October 2, 2009

Project Name:	The Bay House	Project ID:	09-99600006
Address:	113 Newbury Street	CBL:	020-D-032-001
Applicant:	Village at Oceangate, LLC		
Planner:	Barbara Barhydt, Development Review Services Manager

On September 22, 2009 the Portland Planning Board considered the Bay House for 82 residential units, commercial space, and two levels of parking with 159 spaces. The Planning Board reviewed the proposal for conformance with the standards of the Subdivision Ordinance and Site Plan Ordinance. The Planning Board voted unanimously (4-0, Lewis, Lowry, and Tevanian absent) to approve the application with the following motion(s), waivers, and condition(s) as presented below.

DATE: 8/3/05 SCALE: 1"=20'
 SHEET 8 OF 15

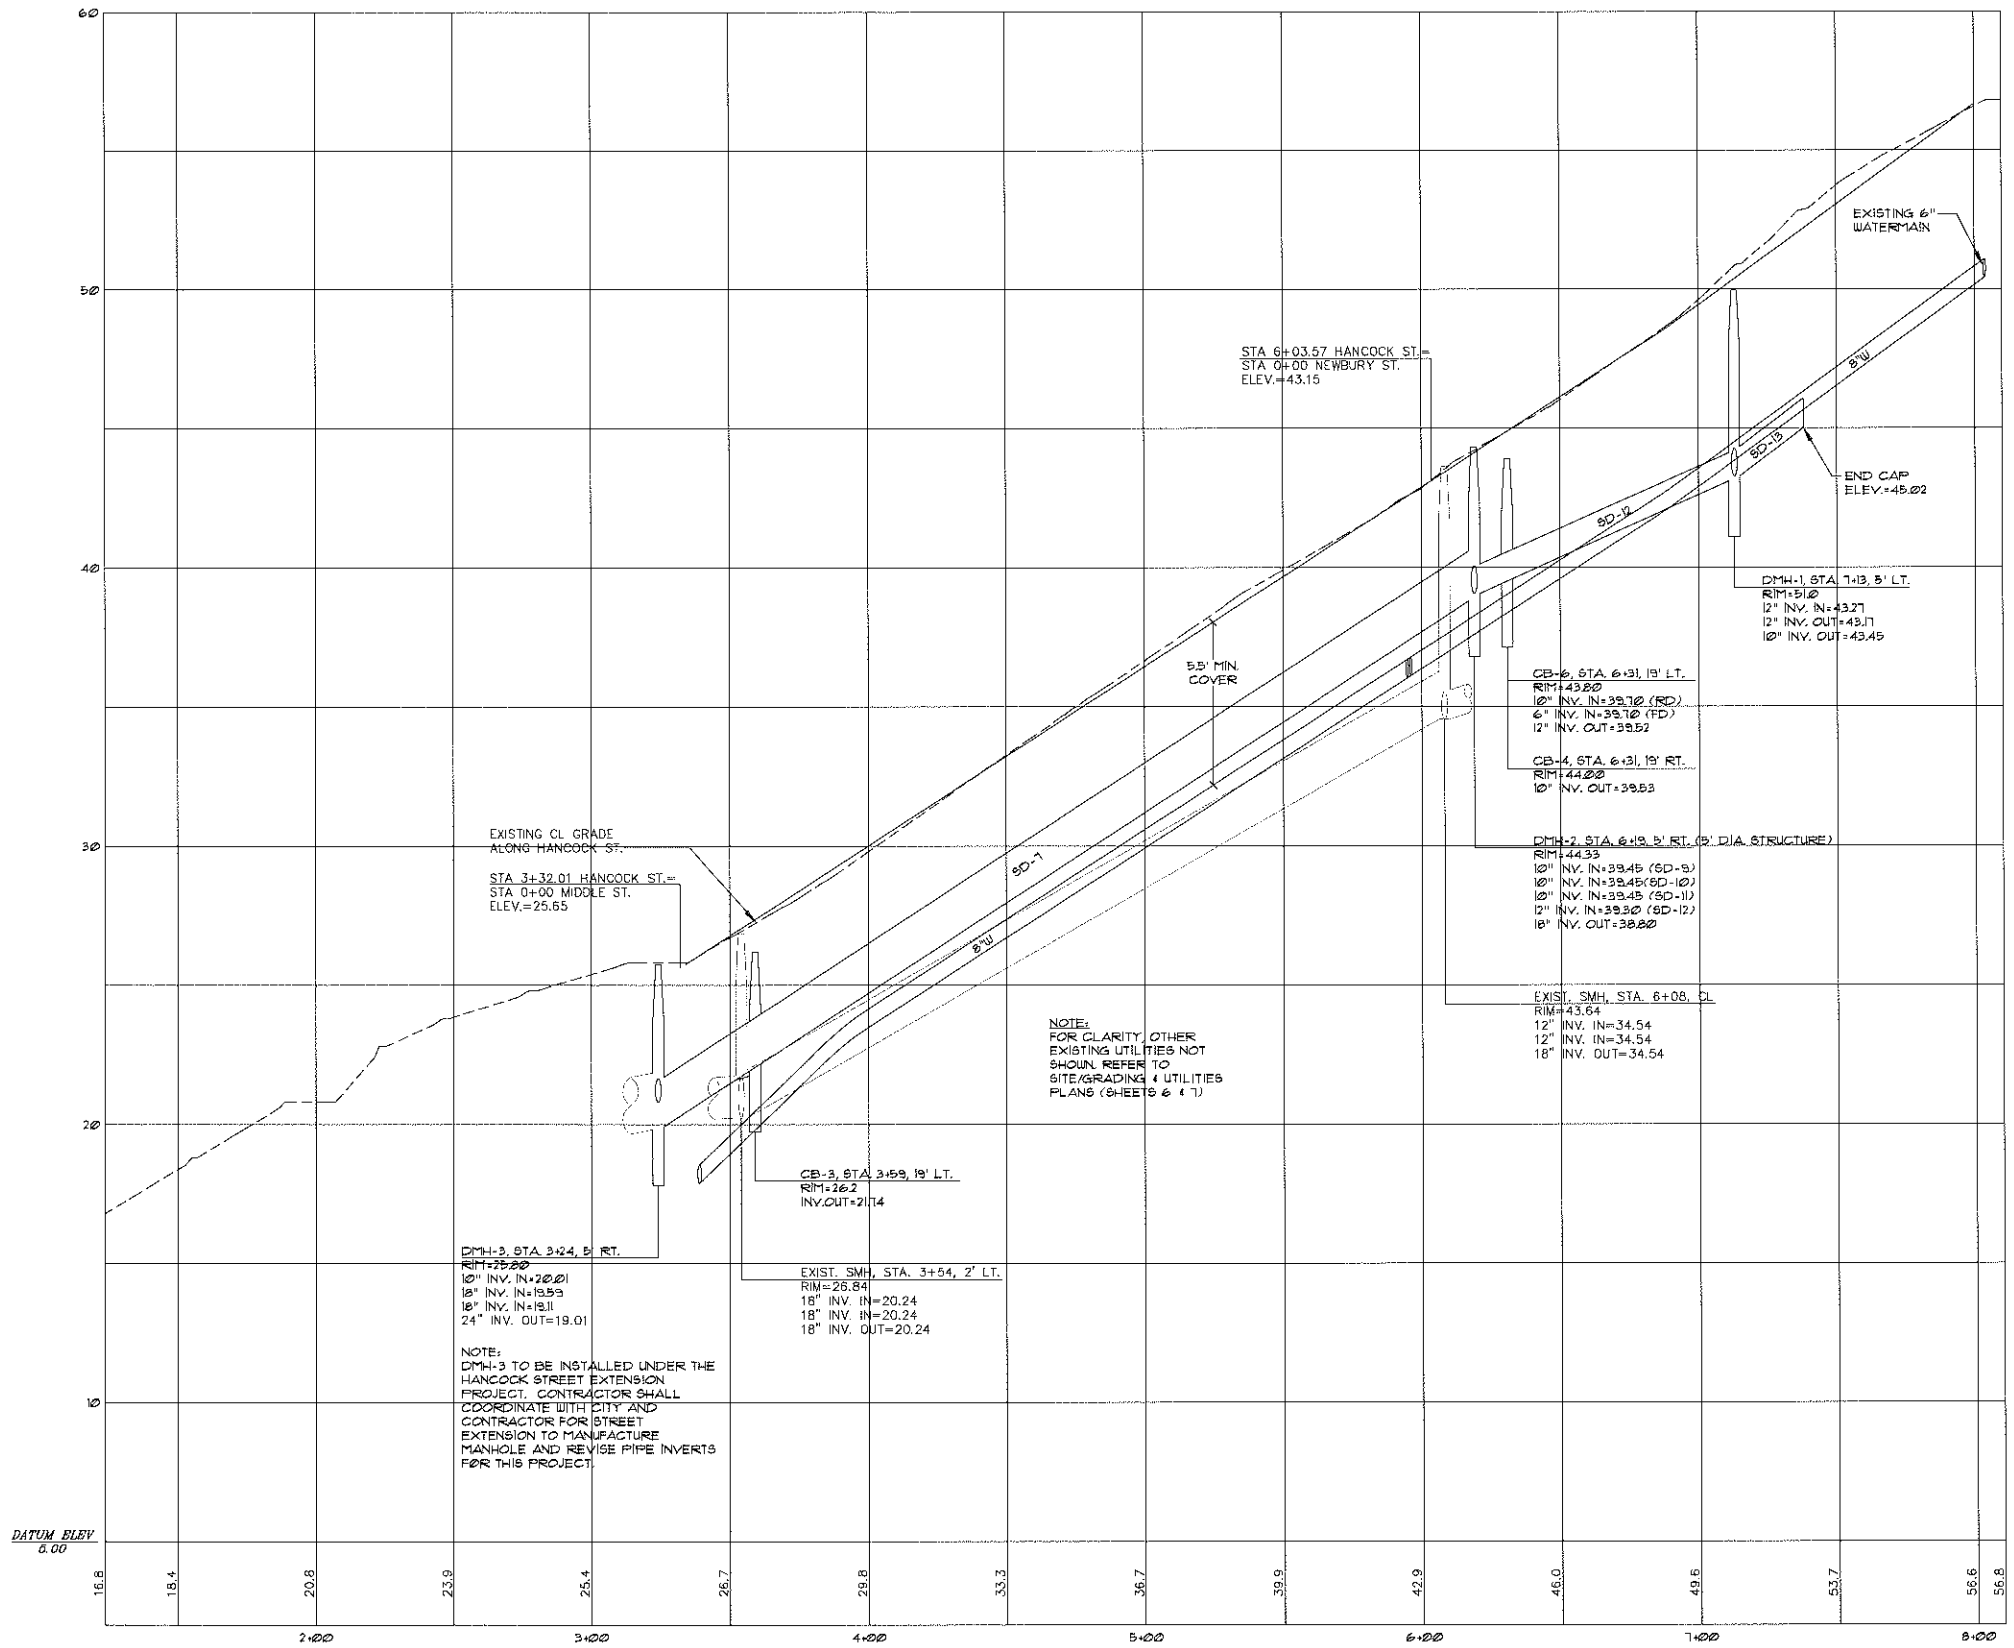
a) **Street-trees** - The street-tree layout looks good as shown on Sheet 8, request would be to check to make sure that tree placement matches any on-street parking or loading zone requirements. Ideal placement of street-trees where on-street parking exists is to have the trees match up to the space between parked vehicles and not mid-car or where passengers were unloading. Tree spacing is also to include review of all underground utilities required set backs. Sidewalk widths should meet ADA standards between the tree grate & building.

SHEET 3 OF 15

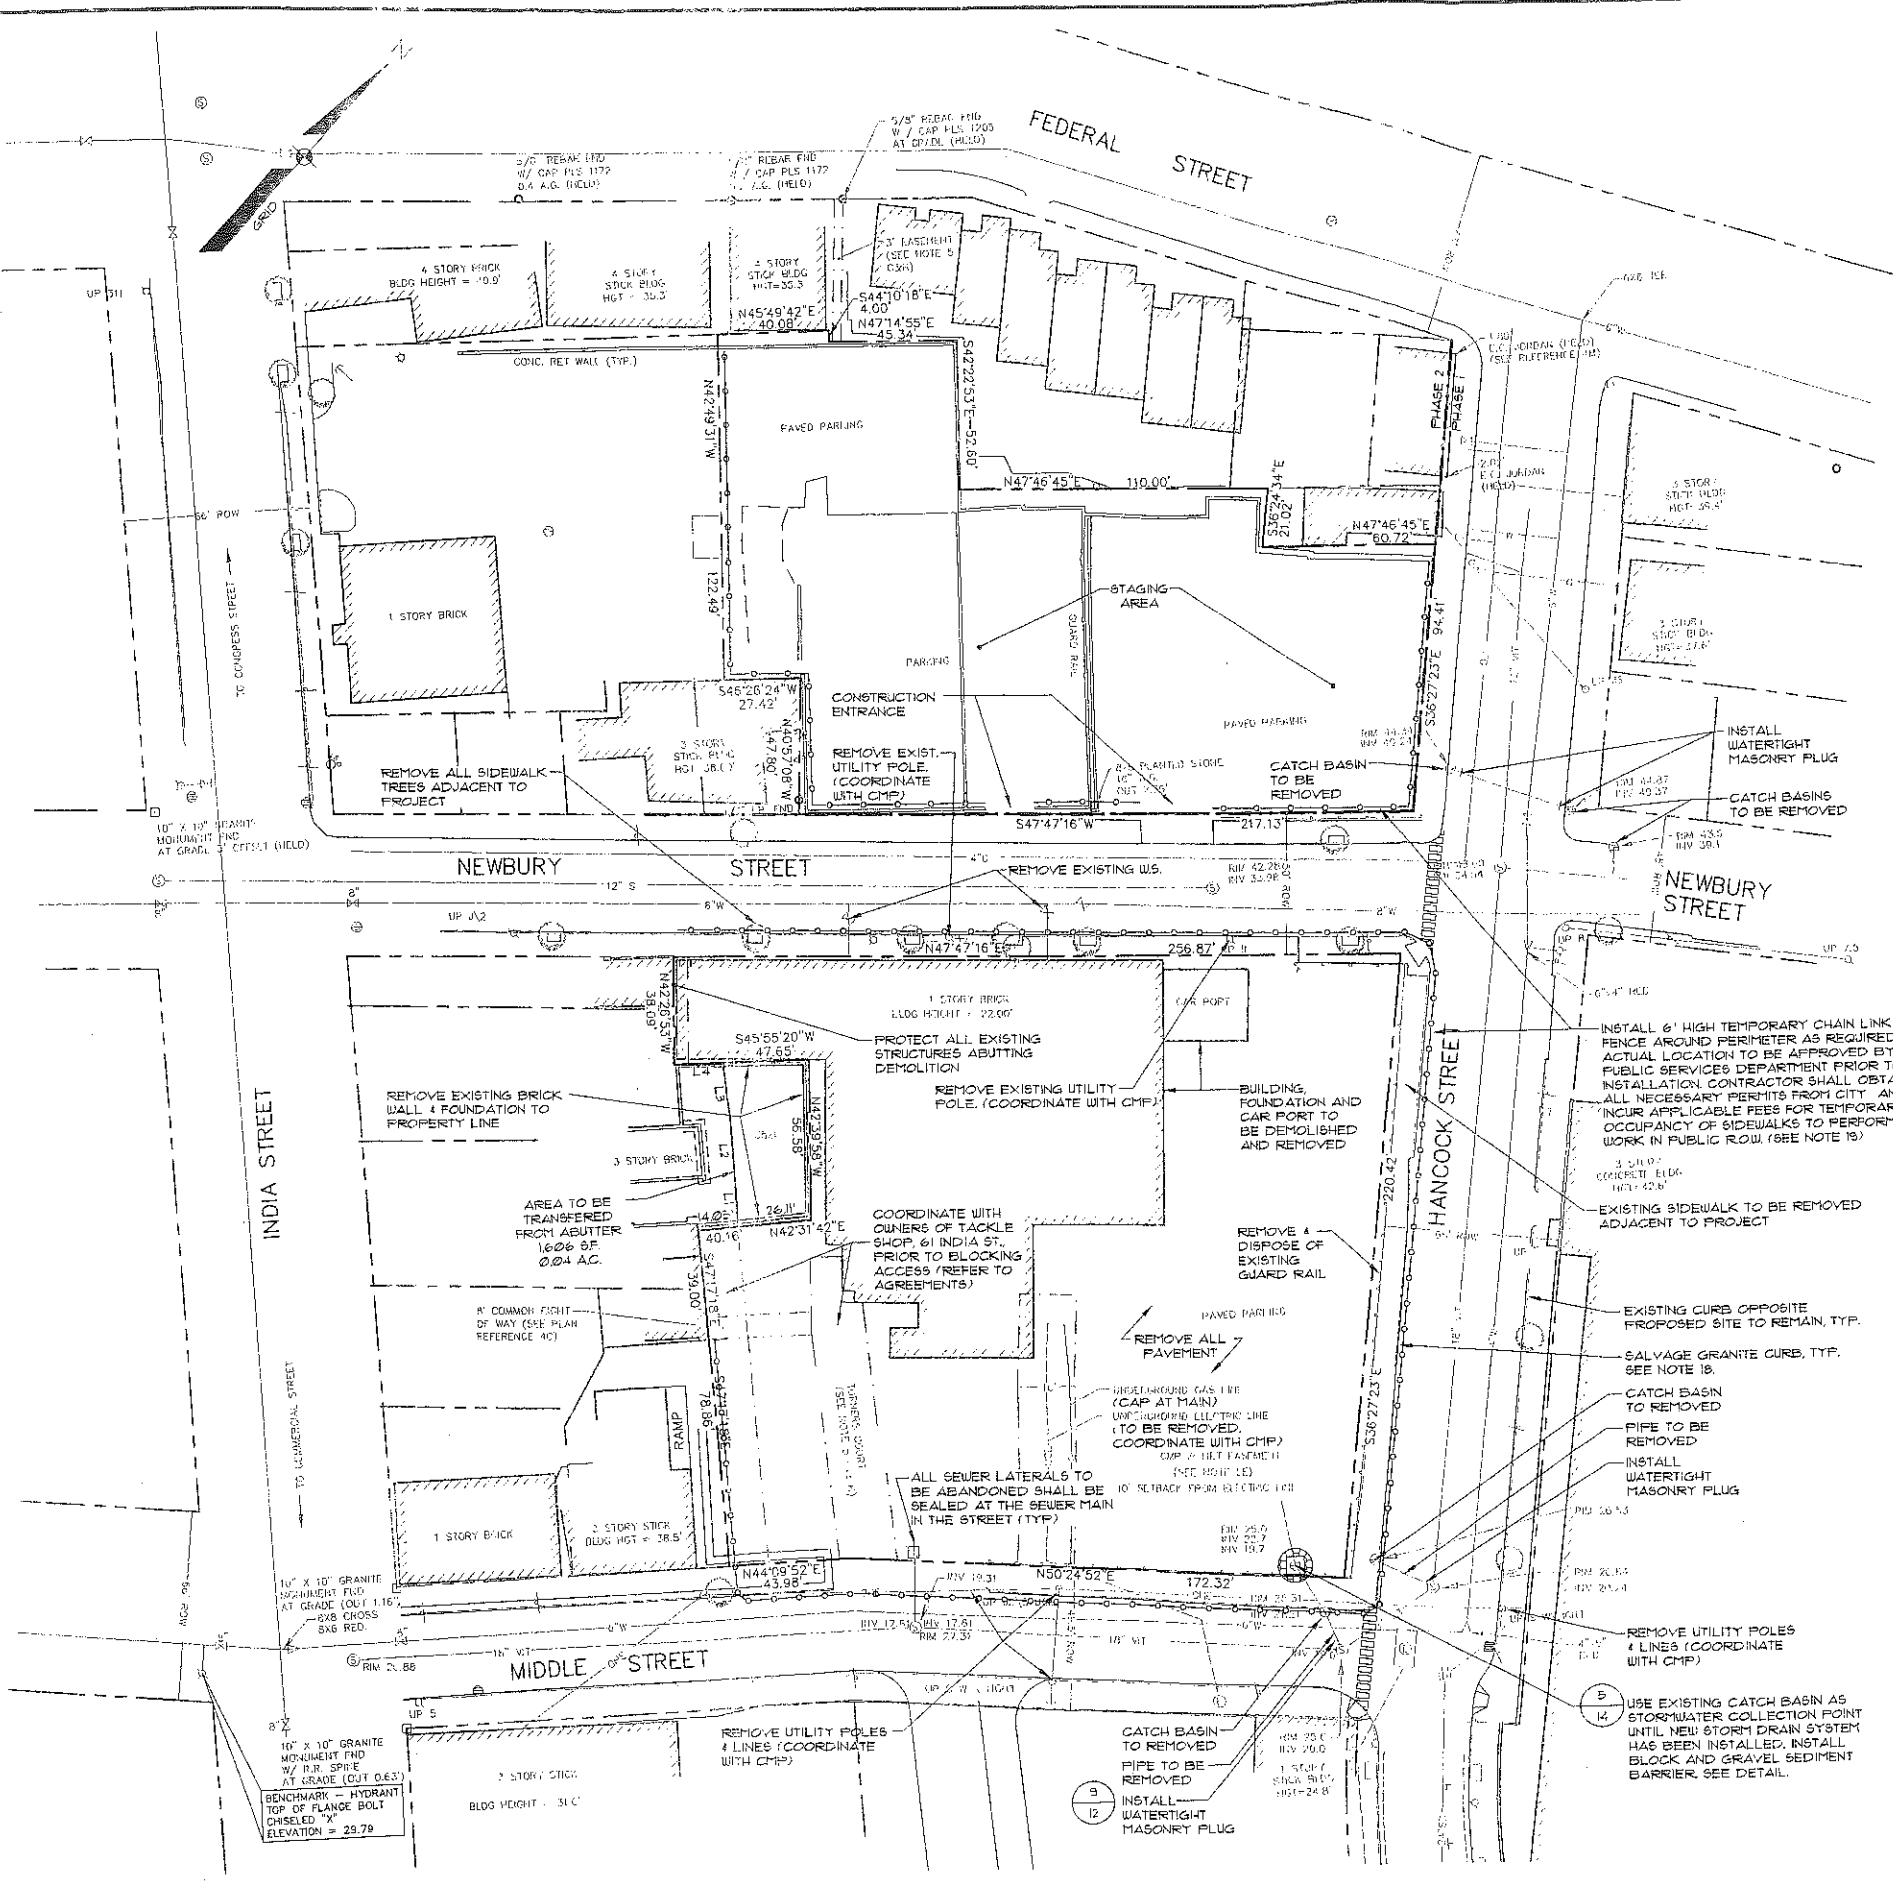
5. Site plan approval for this project should not be construed as City approval for the temporary construction fence shown in the paved street areas on sheet 3 (the demolition plan). The location of the fence will be subject to City staff approval, which will depend on the applicant submitting an acceptable pedestrian

DATE: 8/3/05 SCALE: 1"=20'
 SHEET 8 OF 15

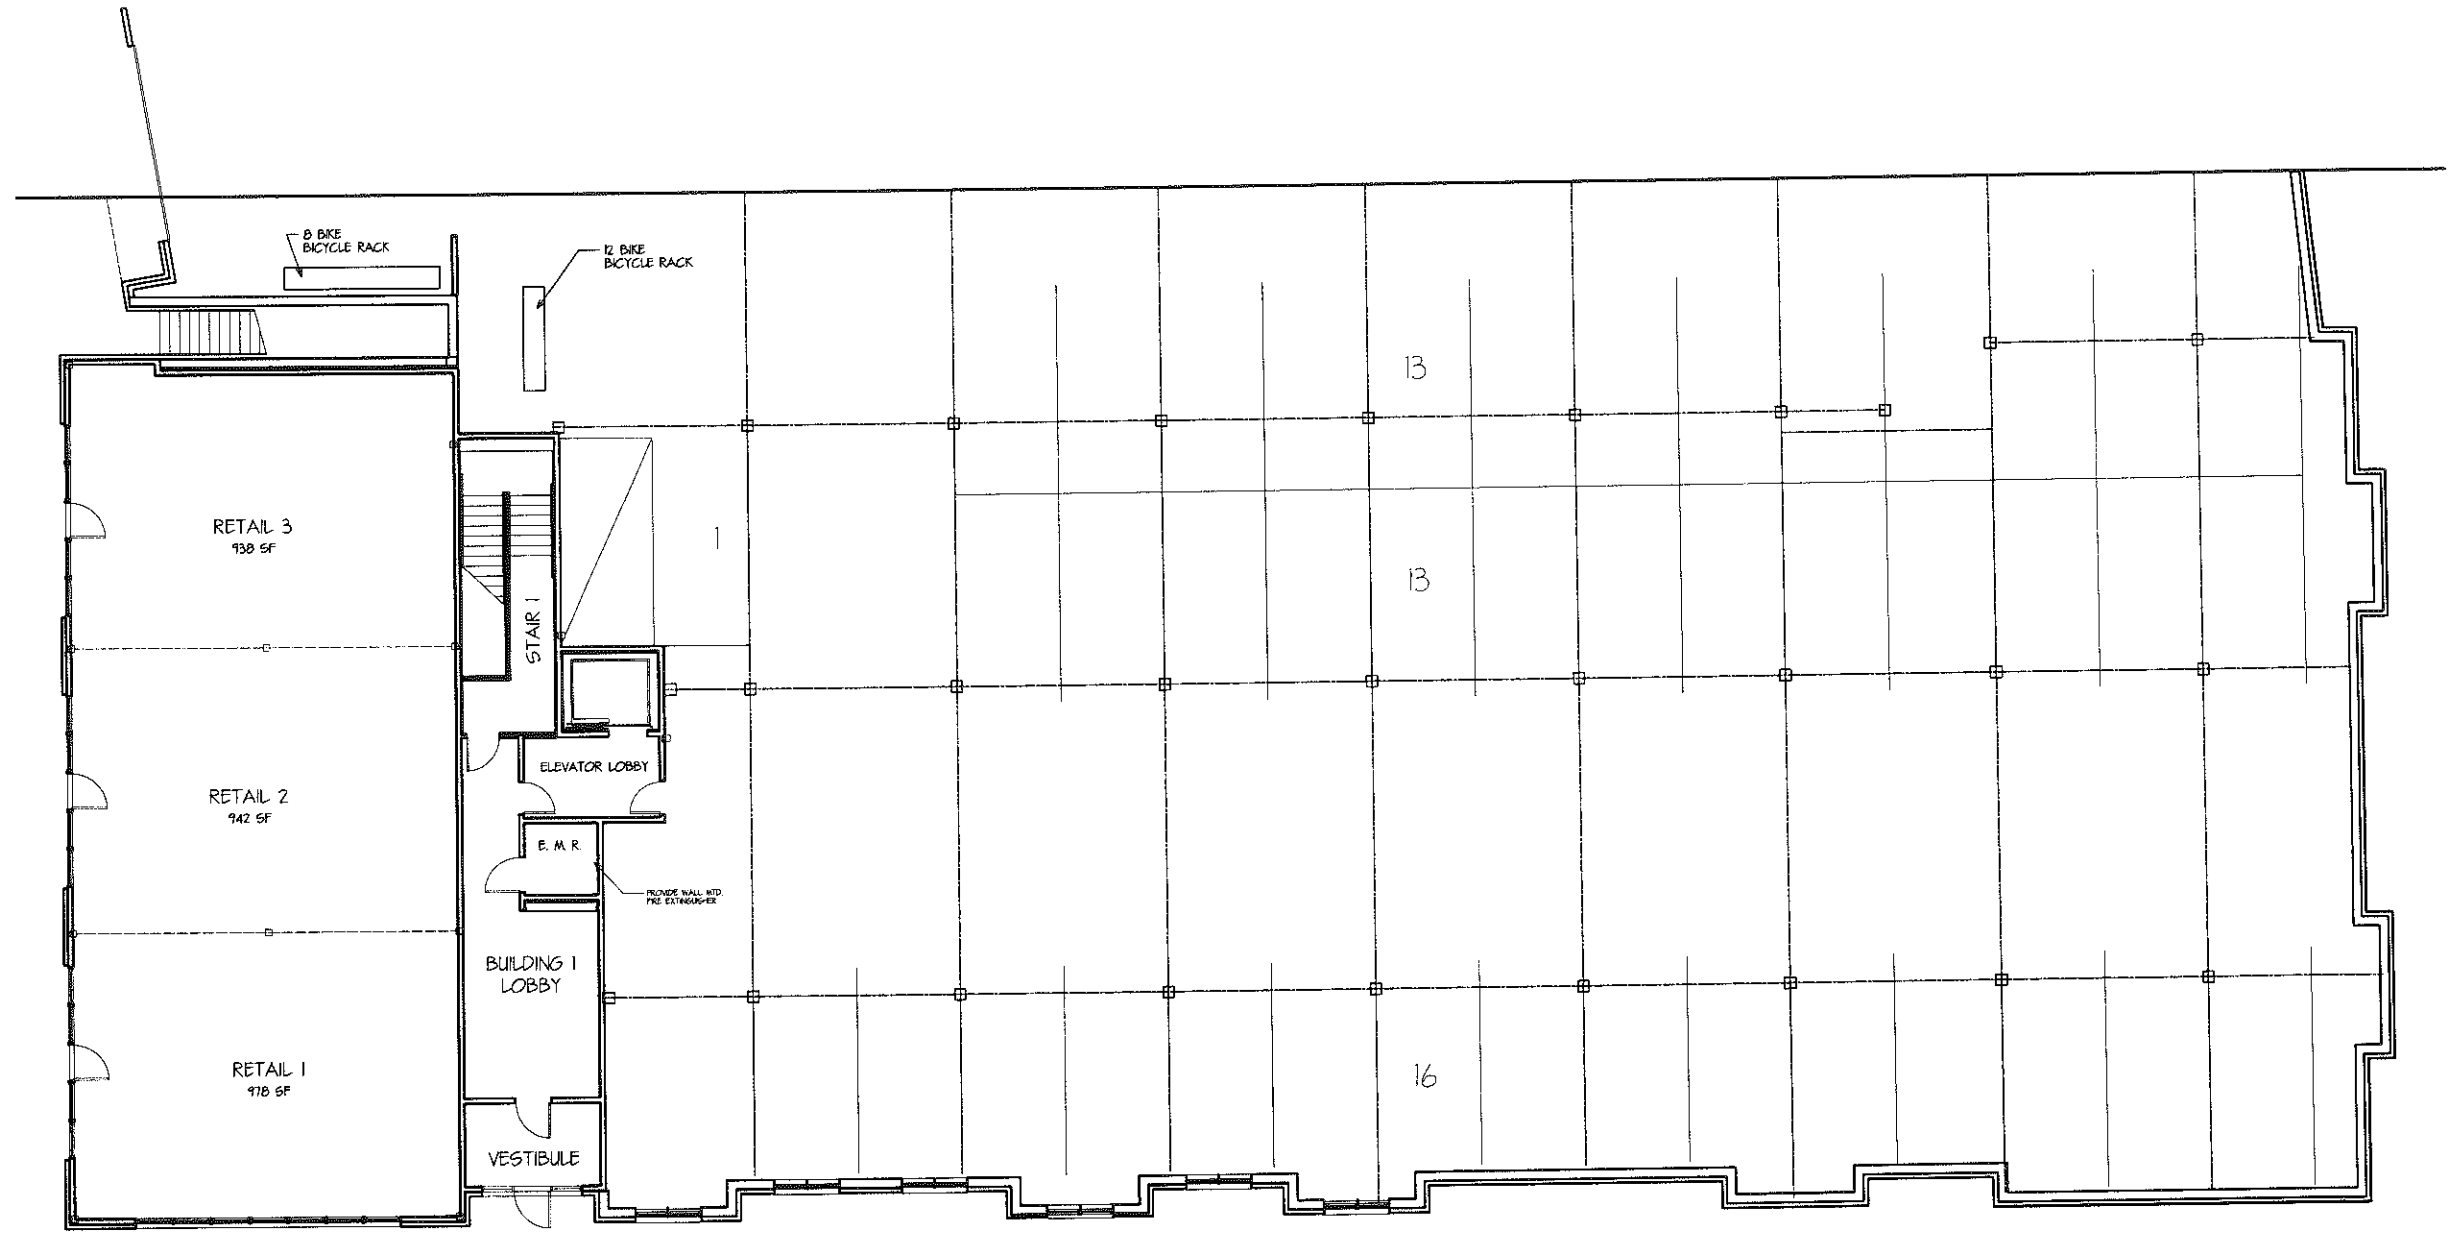
a) **Street-trees** - The street-tree layout looks good as shown on Sheet 8, request would be to check to make sure that tree placement matches any on-street parking or loading zone requirements. Ideal placement of street-trees where on-street parking exists is to have the trees match up to the space between parked vehicles and not mid-car or where passengers were unloading. Tree spacing is also to include review of all underground utilities required set backs. Sidewalk widths should meet ADA standards between the tree grate & building.
